OBJECTION SUBMISSION TO UPGRADES TO CARLINGFORD WEST PUBLIC SCHOOL (CWPS) AND CUMBERLAND HIGH SCHOOL AS PER DPE EXHIBITION NOVEMBER 2022 SSD APPLICATION NUMBER: SSD-43065987

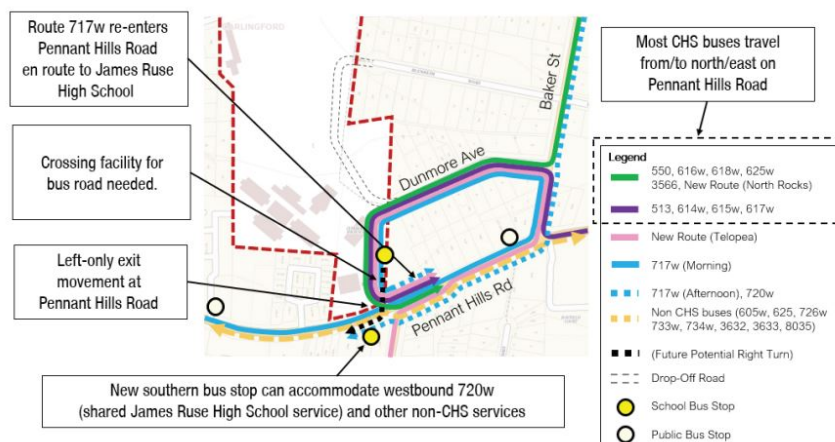
3. Omission of the Telopea Precinct Redevelopment and its shared and cumulative social and environmental impacts with the proposed CHS upgrade plans

In terms of fairness and transparency to the local community and compliance with ethical planning standards and SEARs requirements, I believe it is absolutely critical that details of the proposed massive Telopea Precinct Redevelopment which is only some 2 kilometres away and sits within the current massive outdated CHS enrolment catchment area be recognised as having overlapping cumulative significant environmental and social impacts with the proposed CHS / CWPS Upgrade proposal.

The omission of the massive Telopea Precinct Redevelopment impacts from Section 2.4 “Consideration of Cumulative Impacts” is a major oversight for EIS evaluation purposes.
